Subject: **Modification Request for Section 404 Individual Permit, Individual Section 401 Water Quality Certification, Neuse Buffer Authorization, and Issuance of Tar-Pamlico Buffer Authorization** for the Rolesville Bypass from NC 96 (Zebulon Road) to SR 1103 (Flat Rock Church Road/Clifton Pond Road), Wake/Franklin Counties, Federal Aid No. STP-401(249), State Project No. 81403001, Division 5, TIP R-2814 C. Debit \$570.00 from WBS Element 34506.1.1.

Reference: Section 404 Individual Permit, issued July 14, 2009, USACE Action ID 2008-01316

Please see the enclosed revised permit drawings and impact summary sheets for the above referenced project.

PERMIT DRAWING
SHEET 16 OF 23
REVISED MARCH 8, 2018

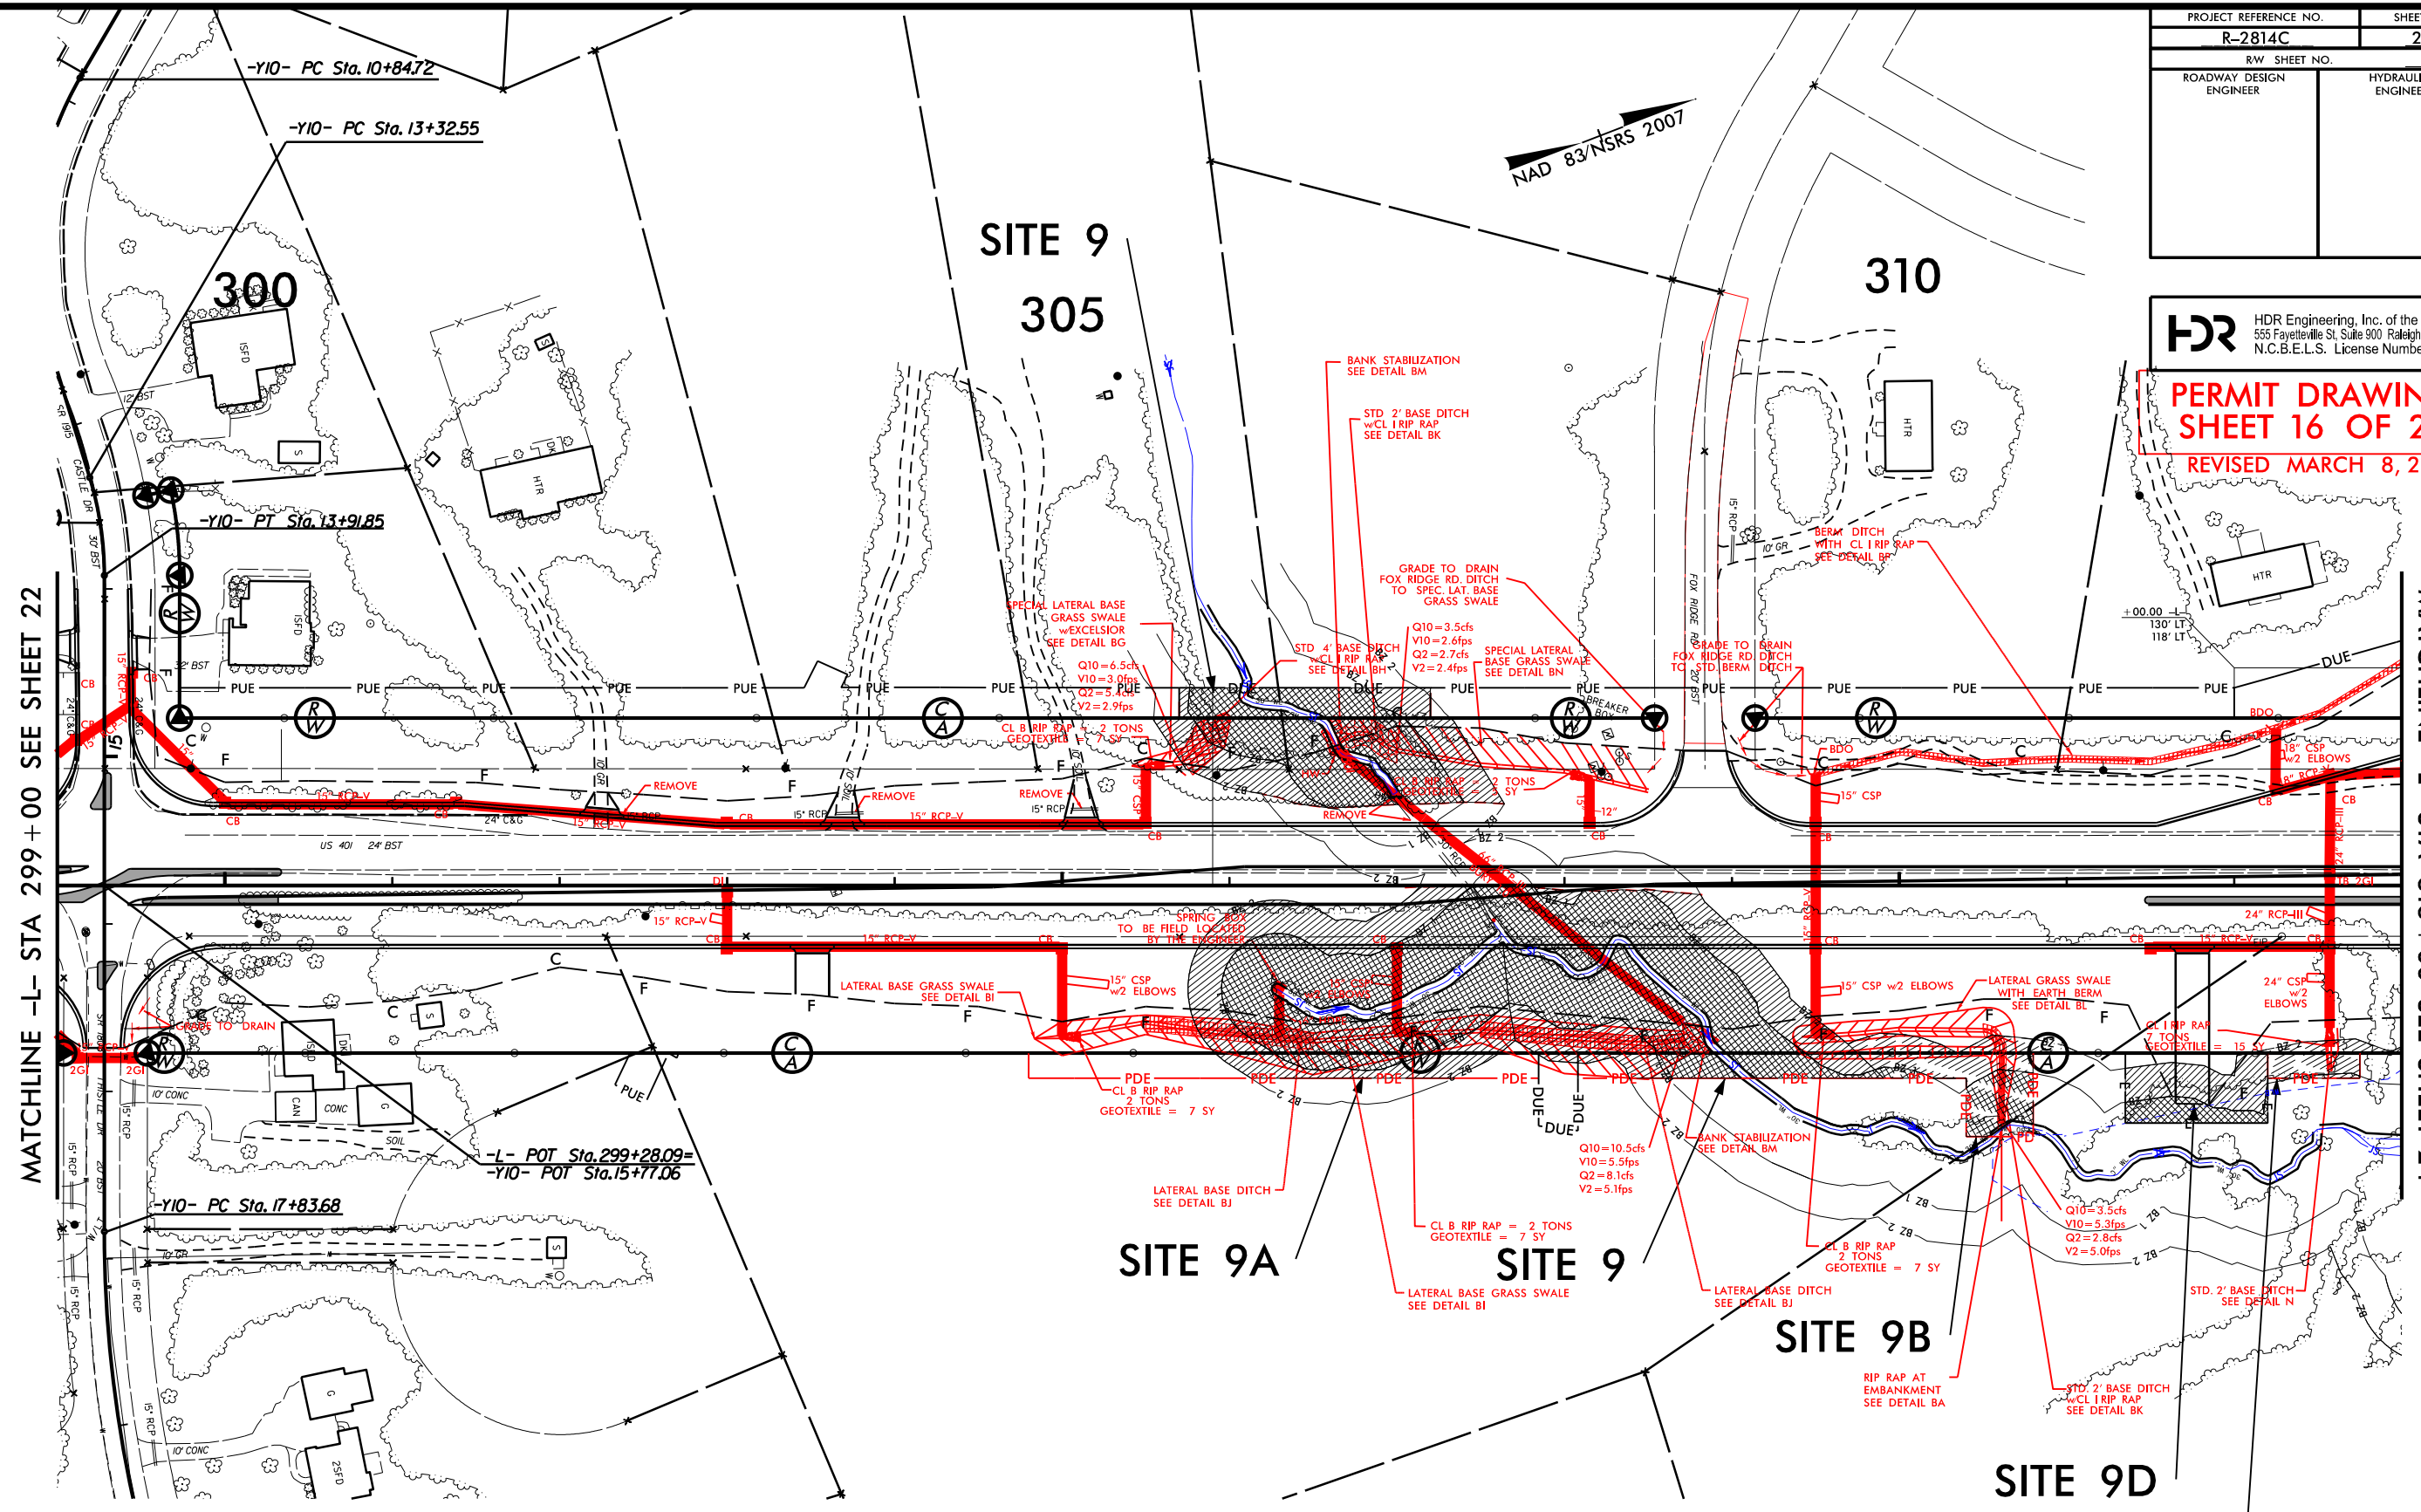
Due to the installation of a new driveway access along US 401 (Sta. -L- 311+74 RT), there will be an additional 0.02 acre of mechanized clearing in jurisdictional wetlands (Permit Drawings Site 13B). An additional impact to Tar-Pamlico riparian buffers will occur due to this work totaling impacts of 1,013 square feet in zone 1 and 1,991 square feet in zone 2 (Buffer Permit Drawings Site 9D).

RIGHT OF WAY REVISION 12-28-16 EAD:
Parcels 89,102,113 & 121 - added text (NO CLAIM).
Parcel 114 - Changed property owner name.
Parcel 115 - Changed property owner name.
Parcel 116 - Changed property owner name.
Parcel 117 - Changed property owner name.
Parcel 118 - Changed property owner name.
Parcel 119 & 120 - Changed parcel nos. to 19Z and 120Z to show 2nd acquisition on parcels.
DESIGN REVISION: MODIFIED U-TURN BULB TO ACCOMMODATE SCHOOL BUS/CEH 8/14/17.

MARCH 8, 2018 REVISION INCLUDES NEW SITE 9D
ADDED FOR NEW DRIVEWAY
